# Access Compliance Report

## Public Rights-of-Way

### (Curb Ramps)

Intersection ID: 24399	Main Street: SUMMERLIN_PL	Cross Street: WINDYRUSH_RD	Location: SE
ADA ID: A746729FEFC0	Ramp Type: PerpDiag	Initial Pass/Fail: Fail	Overall Compliance: No
Severity Score: 12.5			
Codes/Mitigation Info/Possible Solution		Field Measurements/Component Compliance

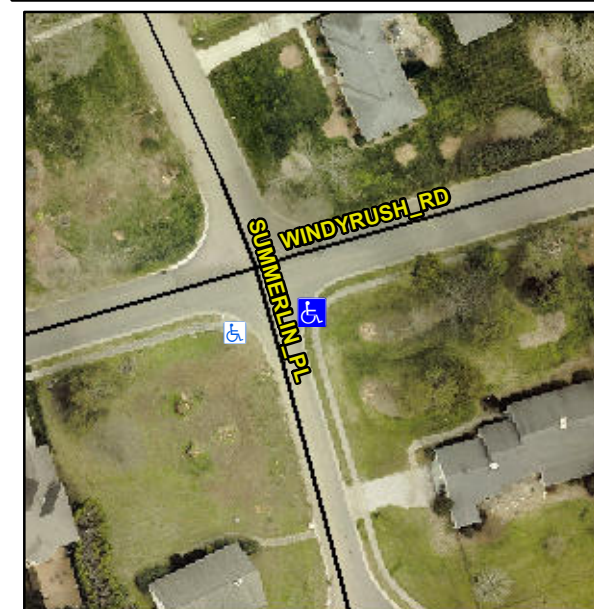
**Not Found, R304.2.2**

Compliance	Description	Data	Compliance	Description	Data
N/A	Ramp Length (in)	49.0	No	Ramp Slope (%)	8.6
Yes	Ramp Width (in)	48.0	Yes	Ramp XSlope (%)	1.7
N/A	Flare Type LT	N/A	N/A	Flare Type RT	N/A
N/A	Flare Slope LT (%)	N/A	N/A	Flare Slope RT (%)	N/A
N/A	Flare Traversable LT?	N/A	N/A	Flare Traversable RT?	N/A
N/A	Landing Length (in)	N/A	N/A	DWS Provided?	N/A
N/A	Landing Width (in)	N/A	N/A	DWS Contrast?	N/A
N/A	Landing Slope (%)	N/A	N/A	DWS Length (in)	N/A
N/A	Landing X Slope (%)	N/A	N/A	DWS Full Width?	N/A
N/A	Landing Curb? (Y/N)	N/A	N/A	DWS Offset (in)	N/A
N/A	Shared Landing?	N/A			
N/A	Gutter Ponding?	N/A	N/A	Gutter Slope (%)	N/A
N/A	Gutter Lip Ht (in)	N/A	N/A	Gutter X Slope (%)	N/A
N/A	Painted X Walk1?	No	N/A	Painted X Walk2?	No
	X Walk 1 Direction	To N		X Walk 2 Direction	To W
N/A	X Walk 1 Width (in)	N/A	N/A	X Walk 2 Width (in)	N/A
	X Walk 1 Slope (%)	5.6		X Walk 2 Slope (%)	4.4
	X Walk 1 X Slope (%)	3.9		X Walk 2 X Slope (%)	4.5

**Remove & Replace Curb Ramp With Two New Directional Ramps or Equivalent.**
